January 3, 2017

ADDENDUM NO. ONE to the plans and specifications for the FARMINGTON PUBLIC SCHOOLS, 2018 RENOVATIONS ELEMENTARY SCHOOLS, Farmington, MI, Architect's Project No. 171712A, dated November 21st, 2017.

The above plans and specifications are modified, supplemented or augmented as follows, and this ADDENDUM NO. ONE, is hereby made a part of the contract documents.

- ENLARGED NEW WORK PLAN
@ BATHROOMS A114 & A116
- 2
A1.1KB
- SCALE: 1/4" = 1'-0"

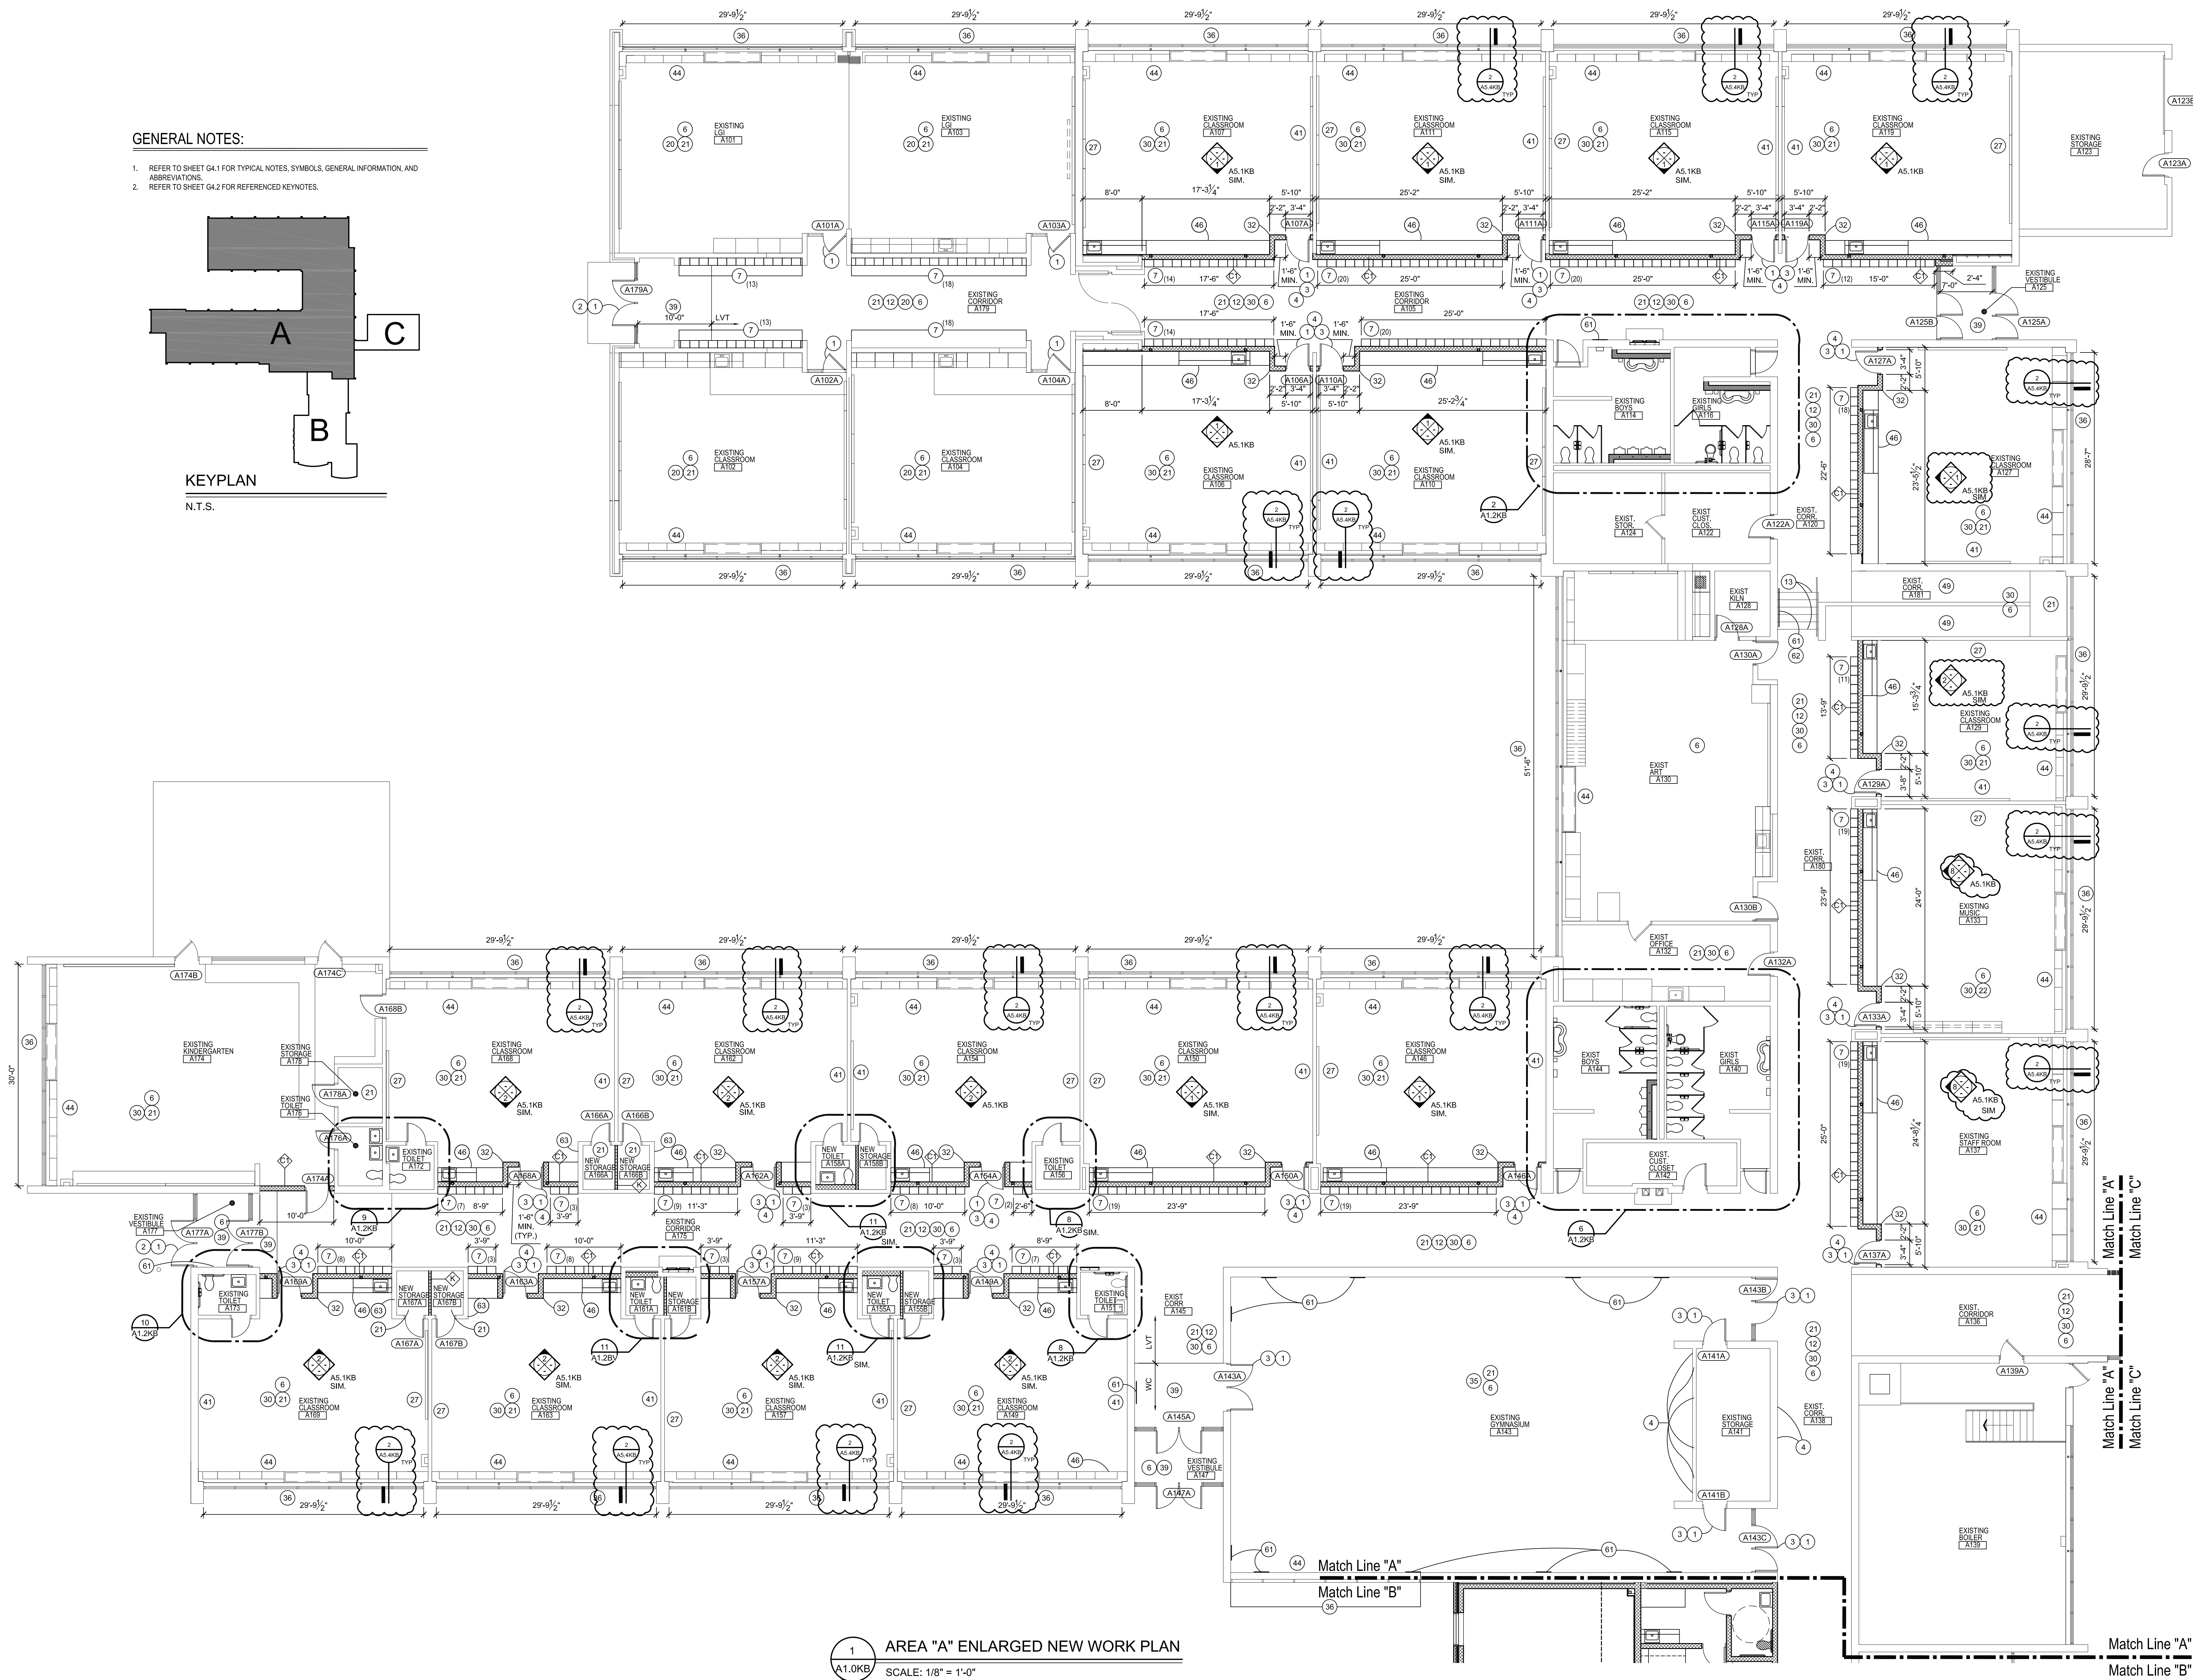
- ITEM NO. A4:** Refer to Drawing No. A1.1KB (Re-issued):

- a. Revised interior elevation tags in rooms A127, A129, A133, A137. Contractor to verify dimension prior to fabrication.

ONE LINE DIAGRAM - NEW WORK
NO SCALE

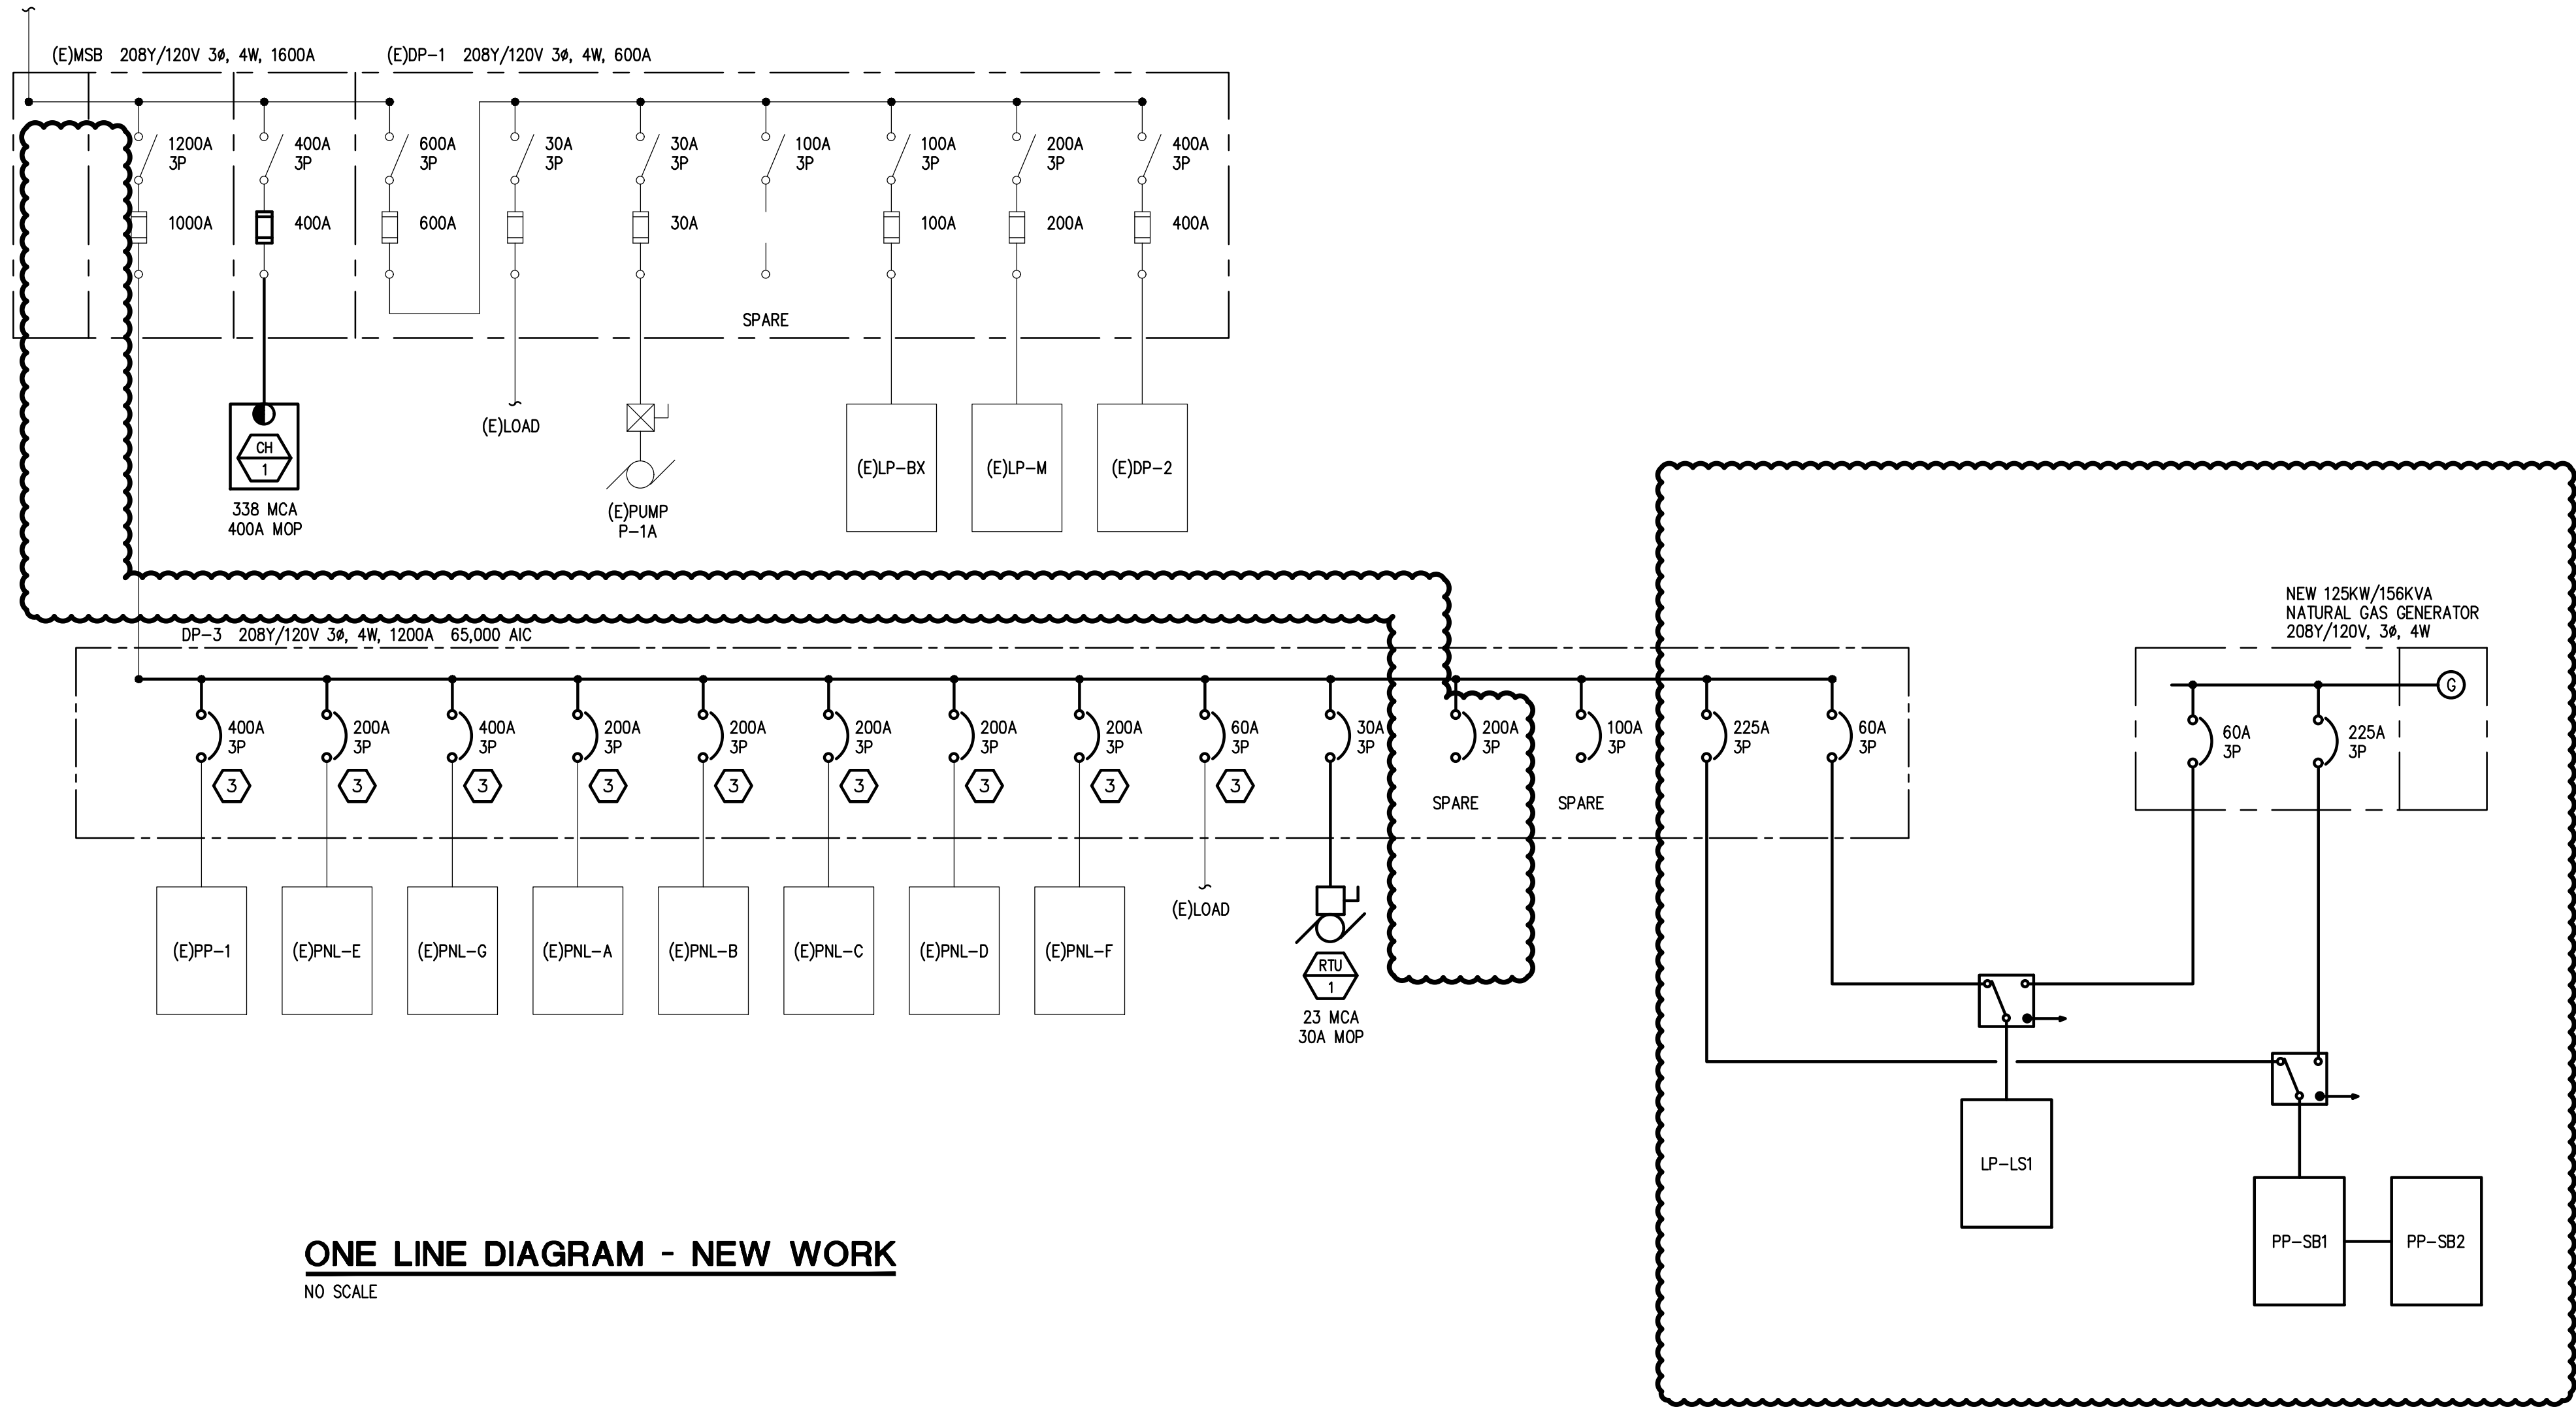
- ITEM NO. E5:** Refer to drawing No. E5.1BV (re-issued):
- a. Generator scope shall now be base bid.
 - b. Revised construction notes 1, 2, and 4 as indicated.
 - c. Revised circuit breaker size to be 200A, 3P as indicated.
